# UNITED STATES PATENT AND TRADEMARK OFFICE

<b>Office Action Summary</b>	<b>Application No.</b> 10/564,827	<b>Applicant(s)</b> HUBER ET AL.	
	<b>Examiner</b> TIEN DINH	<b>Art Unit</b> 3644

## **DETAILED ACTION**

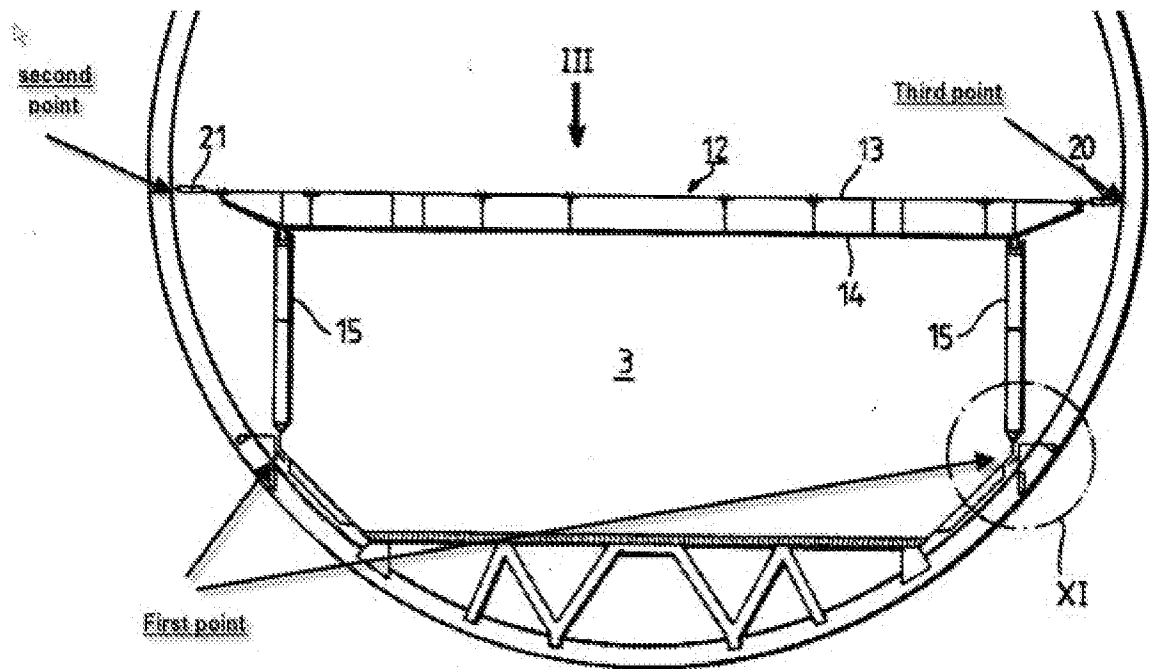
Bergholz, which shows that connect three different points of the floor beam to the fuselage is well known. See the marked up copy below.

It would have been obvious to one skilled in the art at the time the invention was made to have attached the floor beam of Baldwin as modified by Micale and/or Powell and as taught by Bergholz so as to safely attach the prefabricated floor to the fuselage.
